<b>LEXINGTON-FAYETTE URBAN COUNTY GOVERNMENT</b> <b>CONTRACT CHANGE ORDER</b> Page 1 of 2	Date:	April 19, 2016
	Project:	Public Safety Operations Center Phase 1B Renovation
	Location:	115 Cisco Road
To (Contractor): Churchill McGee, LLC 1315-C West Main Street Lexington, KY 40508	Contract No.	287-2014
	Original Contract Amt.	\$6,109,000.00
	Cumulative Amount of Previous Change Orders	\$511,561.93
	Percent Change - Previous Change Orders	8.37%
	Total Contract Amount Prior to this Change Order	\$6,620,561.93
	Change Order No.	13

PROJECT: Public Safety Operations Center Phase 1B Renovation

CHANGE ORDER: 13

SUBJECT: Request a Resolution authorizing the Mayor, on behalf of the Urban County Government, to execute Change Order No. Thirteen (13) to the Contract with Churchill McGee, LLC, for Public Safety Operations Center Phase 1B Renovation, increasing the contract price by the sum of \$29,099.31 from \$6,620,561.93 to \$6,649,661.24 and an additional fifteen (15) working days.

**SECTION DETAIL**

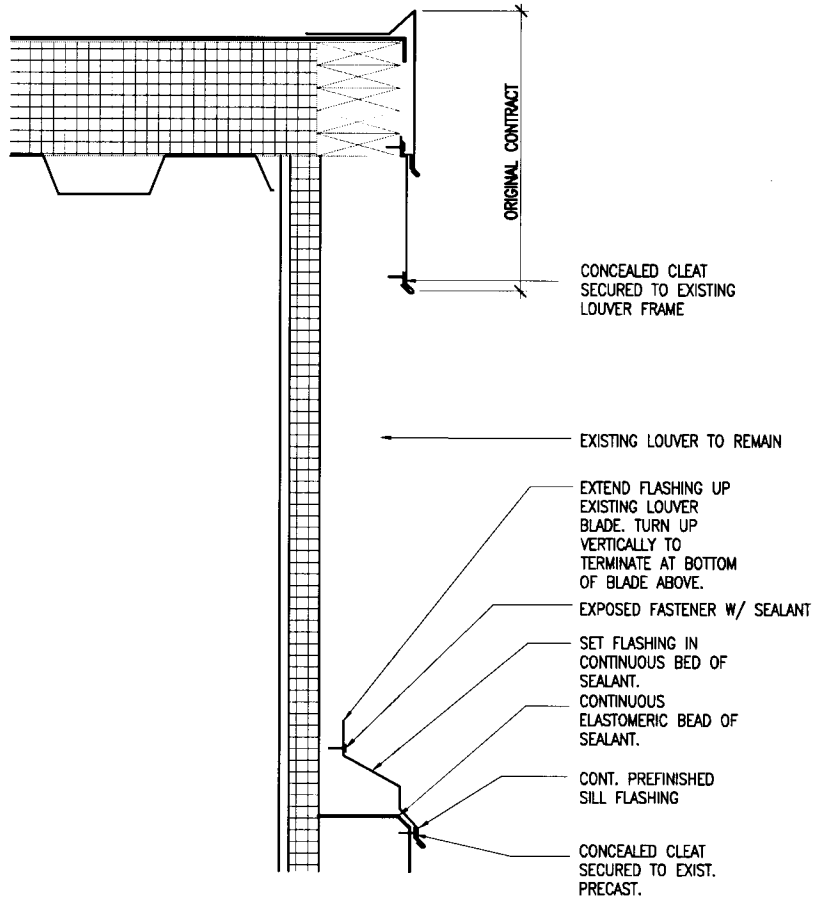
Subject: New Sill Flashing at Existing Penthouse Louvers

- Provide new metal sill flashing along the top surface of the bottom louver blade at each of the existing penthouse louvers. Extend the new flashing profile up the existing louver blade, and turn it vertically up to the bottom of the next blade above.

- Provide concealed cleat & fasteners at the bottom of the new sill flashing.
- Provide exposed fasteners through the new flashing into the existing louver assembly as close to the top edge of the new flashing as possible, to minimize its exposure to weather. Provide sealant closure at each exposed fastener.

- Provide a "corner flashing" piece on top of this new sill flashing at the 90 degree corners of penthouses, where the existing louver blades and the new sill flashing are mitered. This "cap flashing" is meant to flash that exposed miter joint at the corners.

- Provide a metal cover plate on top of each existing drilled or cut opening of various louver blades.
- Where former mechanical units (fans, etc.) have been removed from exterior faces of existing louvers, leaving gaps in continuity of the louver blades, provide new louver blade sections, matching profile of existing blades, as infill in these areas, overlapping adjacent louver blades by approximately 4".

- Provide electrostatic paint coating on all louver surfaces, existing and new, per construction documents (A3.0, A3.1, A4.0) at no additional cost.

AI PHONE INNERCOM RELOCATION  
VESTIBULE V100 ENTRY

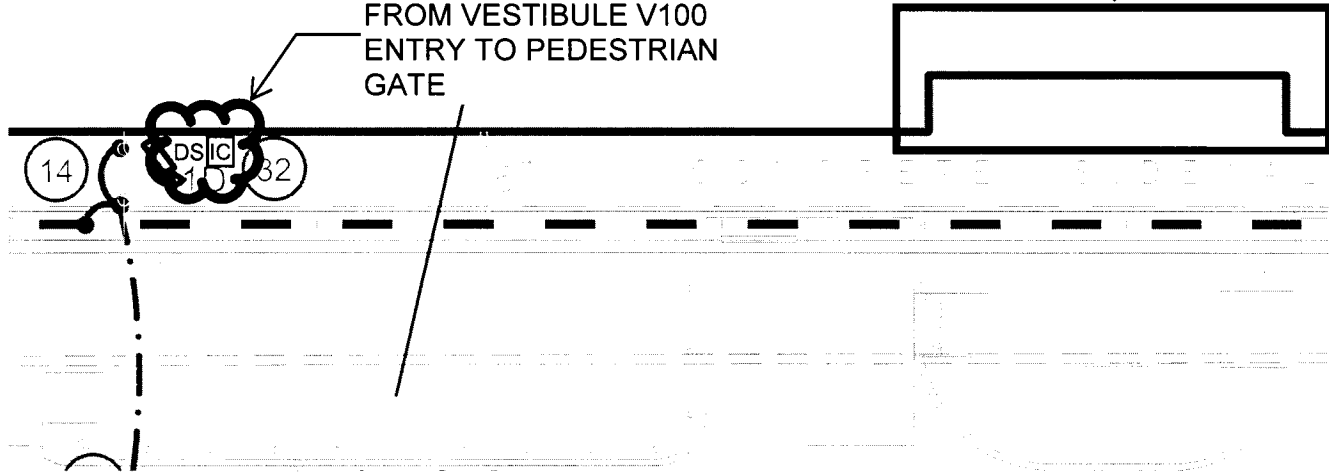
The Contractor shall provide a proposal to locate the AI Phone controller at the pedestrian gate as shown on Sketch XE05, in lieu of Vestibule 100V entrance as shown on the original Contract Documents. Exterior exposed wiring shall be in rigid conduit with the wall mounted AI Phone unit as depicted in Sketch XE05 (24" East of gate and 48" above finish sidewalk grade.) Trigger wiring for gate control shall be routed back to the South West corner of Electrical Room 142 and terminated at the security access control panel to log activity. The Contractor shall also price furnishing and installing (1) additional (22/6 exterior) wire form each of the (2) gates to facilitate access controller communication.

RELOCATE AI PHONE  
FROM VESTIBULE V100  
ENTRY TO PEDESTRIAN  
GATE

Relocate the AI phone from Vestibule 100V to pedestrian gate per sketch XP04.  
 Provide a stainless steel back box for the AI phone at new location.  
 Provide conduit and wiring, also an additional 22/6 cable from gate controller.  
 Price does not include any lightning arresters. None called for in Proposal request.

1. MCP Data Rack Layout

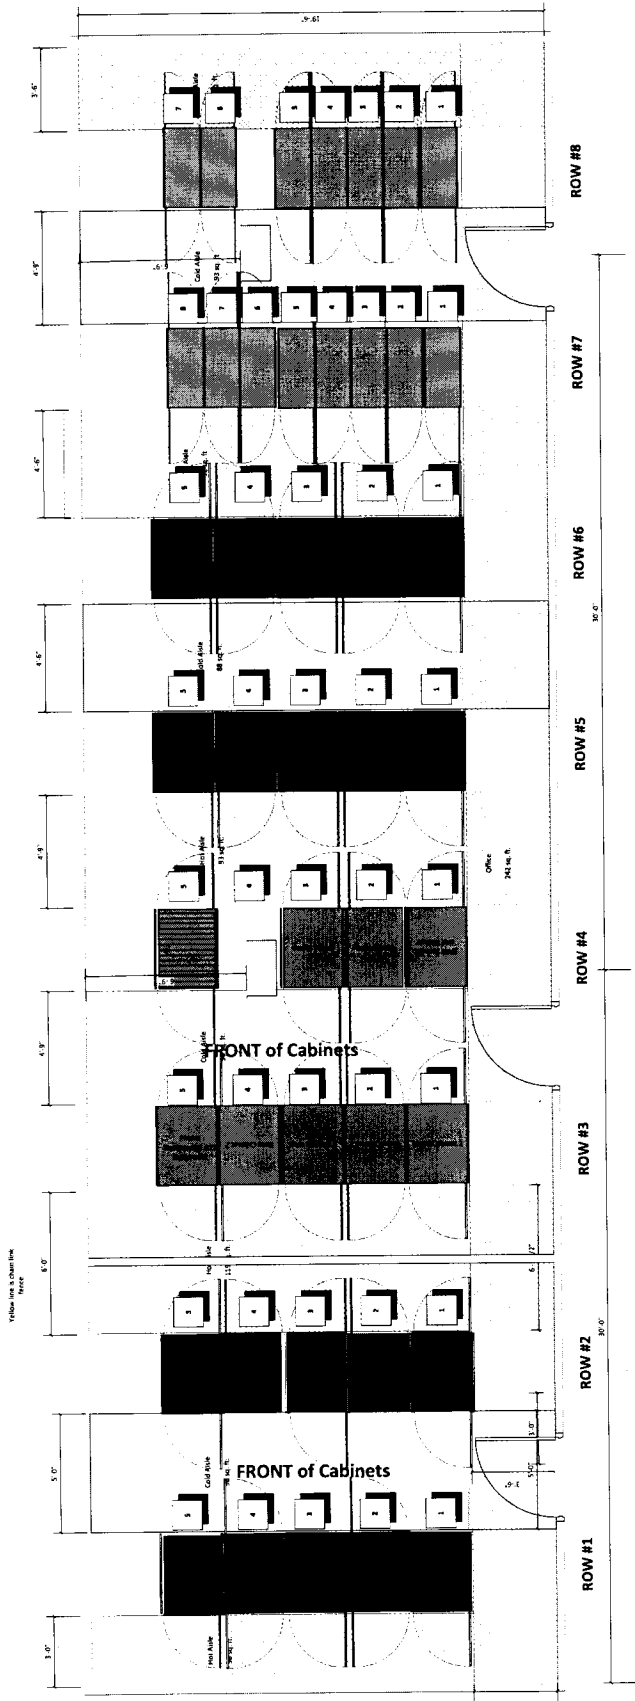
The Contractor shall provide a proposal to make the following changes and additions. The Owner requested that approximately 66 data drops located in rooms 148, 150, 153, 154, 155, 132, 138, 139, F101A, F101B, 143 and 144; be terminated in a separate Cabinet (provided by LFUCG) located on the west side of Room 140 located in Row 2 Cabinet 1 (See Attached Layout). Two patch panels are required for these terminations. Relocate one 48 port patch panel from the data cabinet that was previously serving the drops.

The Contractor shall furnish and install one (1) additional 48 port patch panel in the newly designated data rack. The Contractor shall install the Owner furnished rack as well as furnish and install the rack mounted ground bar (RGB) and grounding connections in accordance with Construction Note 16 on Drawing E1.7.

Re-route 70 cables, as outlined in PR 50 to cabinet in second row of MDF (Room 140).

One new patch panel, wire manager, and ground bus will be furnished and mounted in cabinet. Attaching ground bus grounding wire by others.
